Noise considerations for 40/100GBASE-CR4/10

Adam Healey
LSI Corporation

IEEE P802.3ba Task Force Meeting
San Francisco, CA
July 2009

Insertion loss to crosstalk ratio

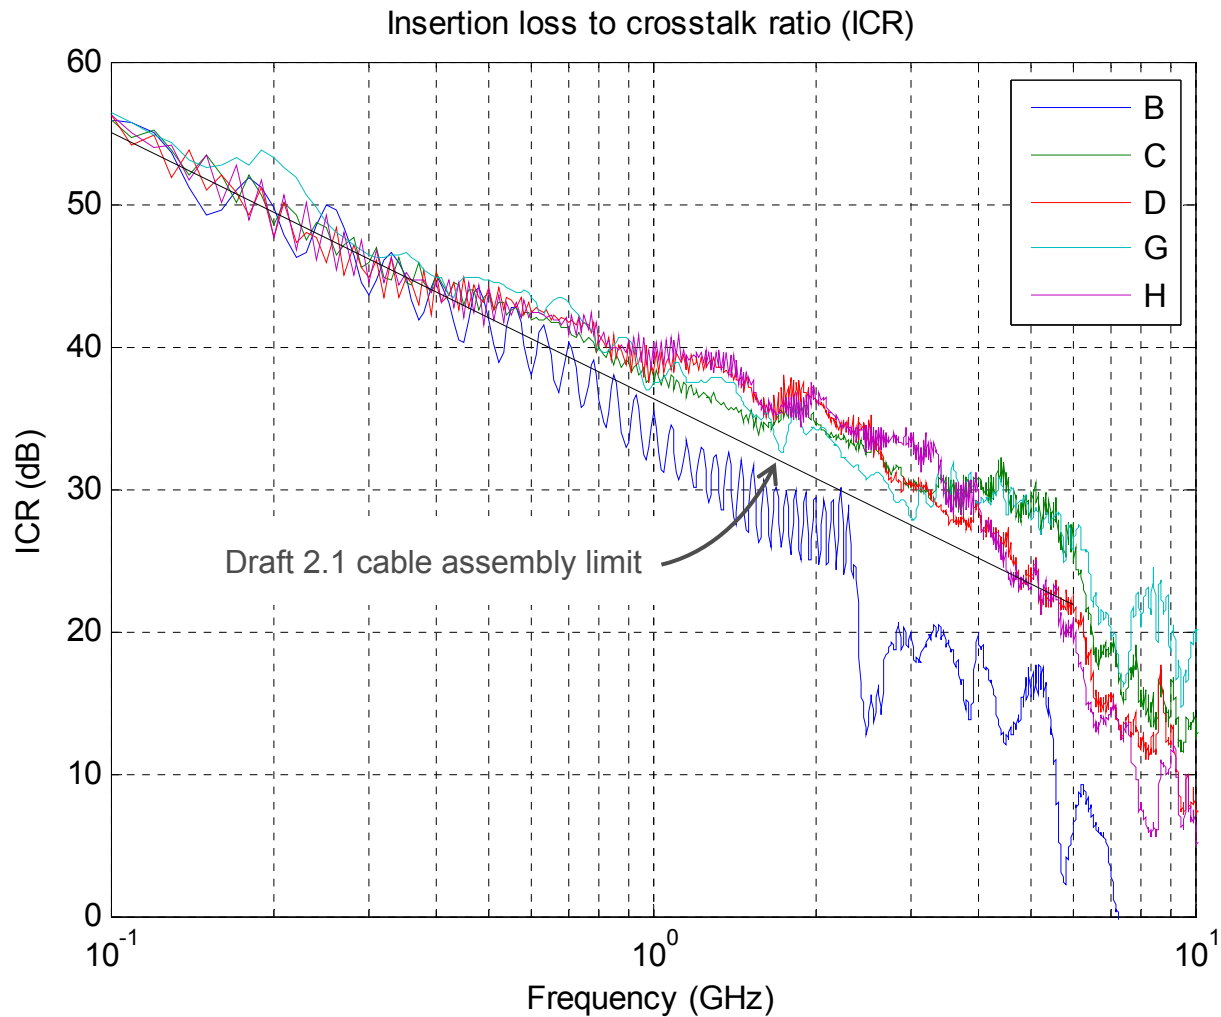
Insertion loss to crosstalk ratio – Comments #141, #293

- Insertion loss to crosstalk ratio (ICR) limit predicts a larger RMS crosstalk amplitude than what may be derived from the measured cable assembly crosstalk transfer functions
- The ICR is used as the basis for definition of the random interference stress applied during receiver testing (note 1)
 - Why not apply the same calculation to the cable assembly and achieve a clearer coupling between cable assembly and receiver requirements?
- It has been pointed out (note 2) that the log-linear fit to the calculated ICR sometimes produces limit violations even the calculated data appears to be in the acceptance region
 - It turns out that, for the specific case cited, this behavior was due to an error in the calculation of ICR
 - With the error corrected, the calculated ICR violated the limit hence the log-linear fit was not producing a false negative in this case

Integrated crosstalk noise (ICN)

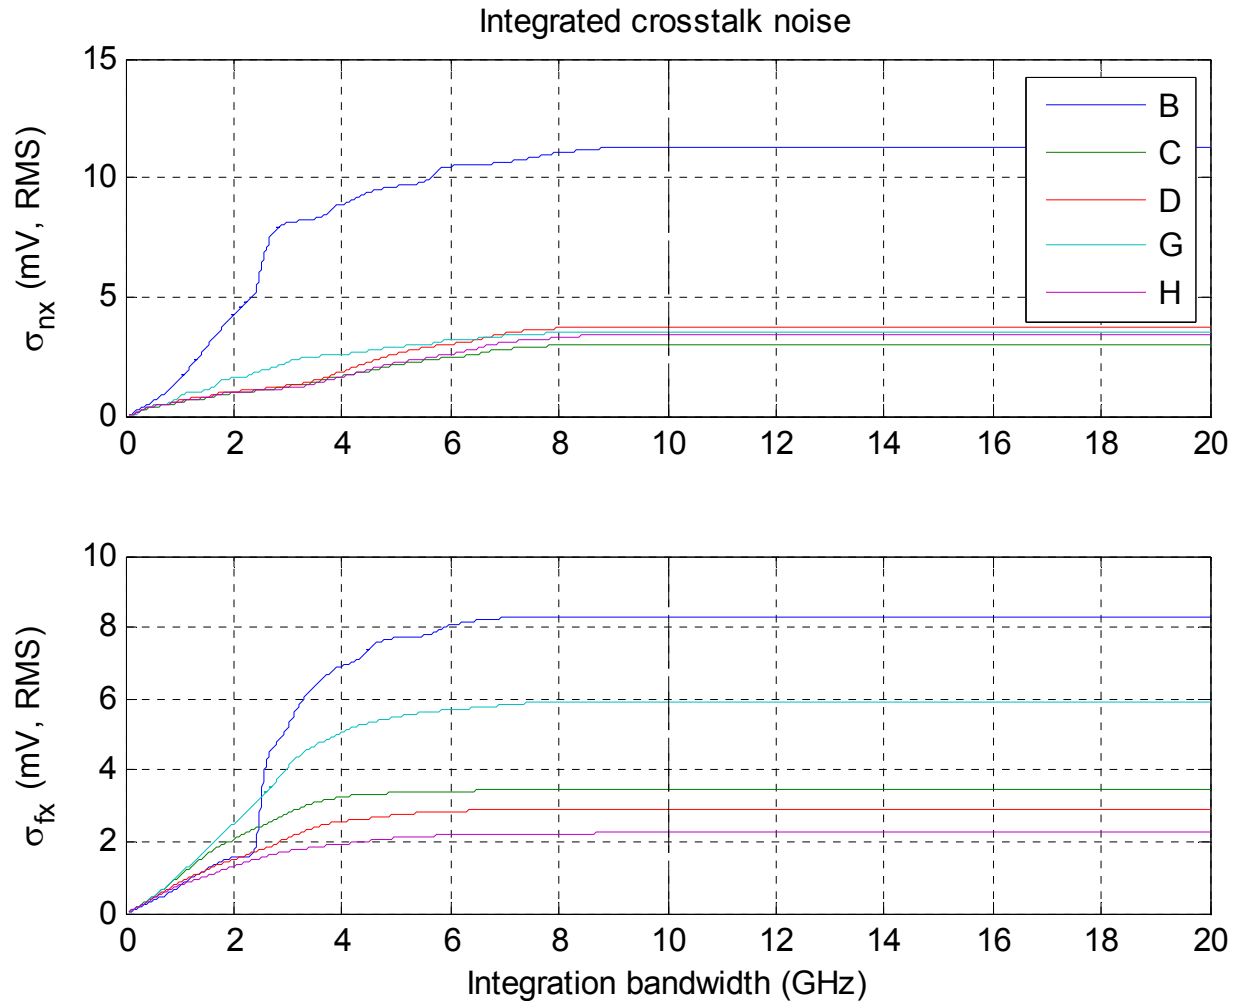
An integration bandwidth of 10 GHz is sufficient to capture all of the noise

ICN with host printed circuit boards

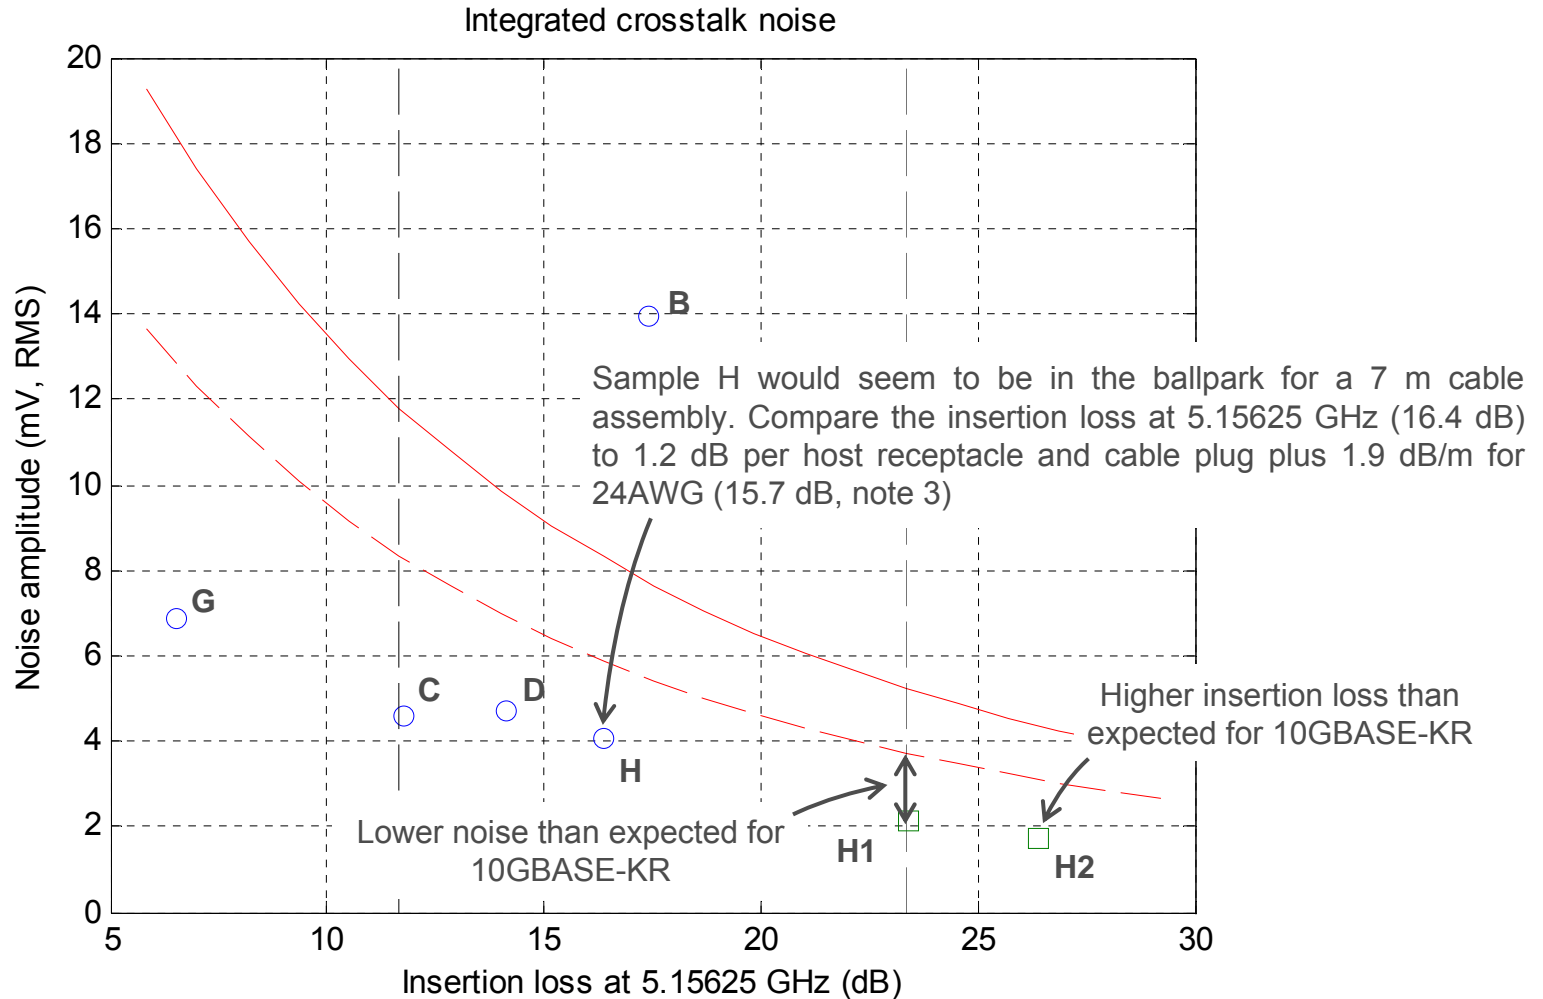
- Comment #96 suggests that the host printed circuit board (PCB) and connector insertion loss allowance be increased
 - 5.0 dB at 5.15625 GHz for the PCB trace, connector, and other impairments
 - 3.5 dB at 5.15625 GHz for the PCB trace only
- To maintain a consistent loss budget, it is recommended that the cable assembly reach objective be reduced to 7 m
 - It is unclear how to minimize double-counting of losses since the mated connectors are included in both the host and cable assembly allowances but there may be differences in the receptacle on the cable assembly test fixture and the receptacle on the host board
- Reconsider the noise calculations with additional host-related losses
 - Assume that the crosstalk coupling between the differential PCB traces is small enough to be ignored

Observations

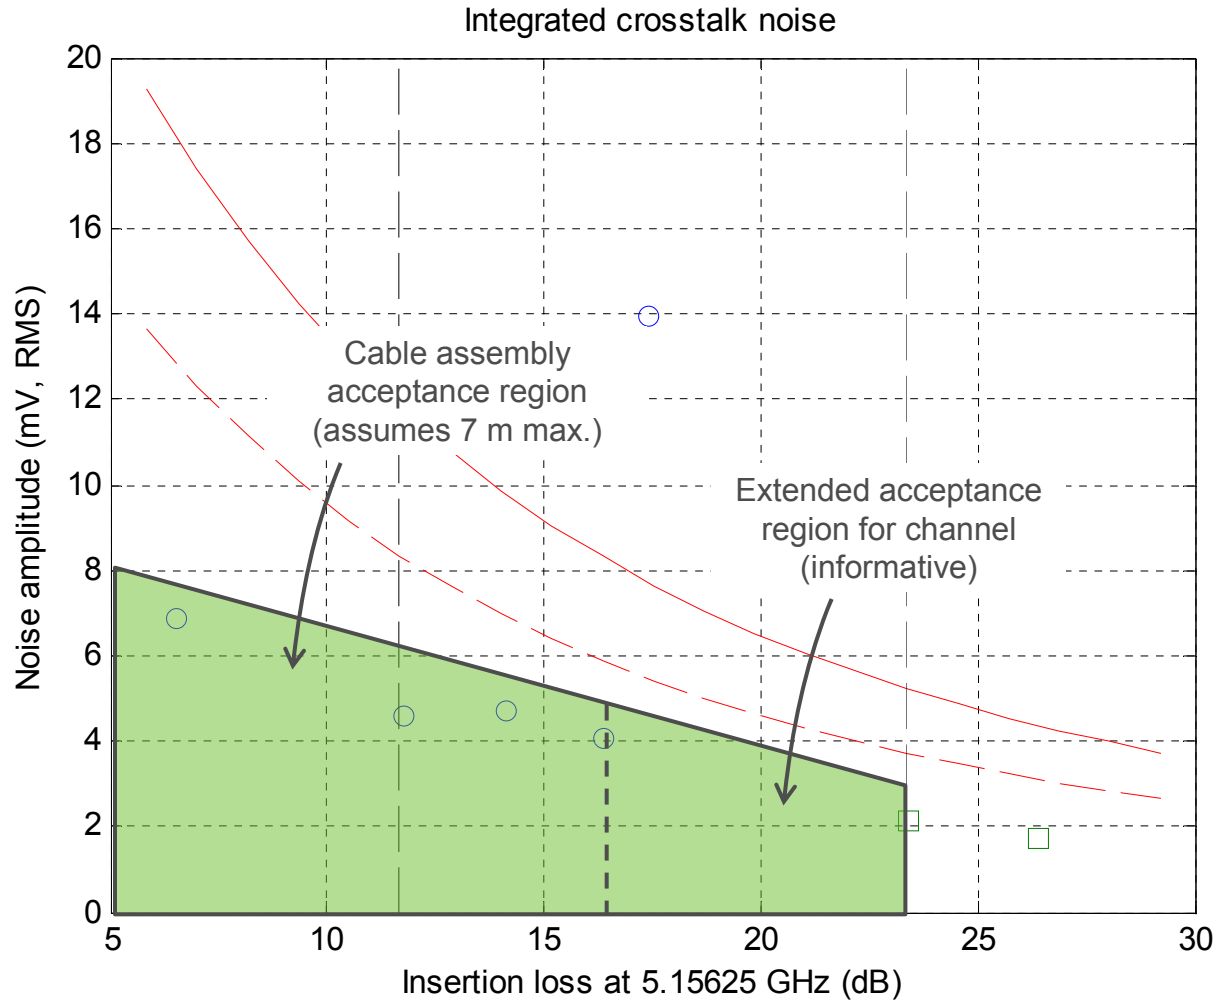
- 10GBASE-KR compliant solutions support a 7 m cable assembly with host transmitter and receiver printed circuit board traces each exhibiting an insertion loss of 3.5 dB at 5.15625 GHz with margin
- The insertion loss for a channel that includes 5.0 dB of printed circuit board trace loss at both the transmitter and receiver exceeds what is currently required for 10GBASE-KR receiver testing
 - Existing solutions may support this operating point but no general statements may be made based on the 10GBASE-KR specifications alone
- It is again important to note that the 5.0 dB case double-counts losses that included in both the host and cable assembly allowances

- Replace existing insertion loss to crosstalk ratio specifications for the cable assembly and channel with integrated crosstalk noise specifications
- Define a region of compliance for the integrated crosstalk noise based on the insertion loss at the fundamental frequency exhibited by the victim pair
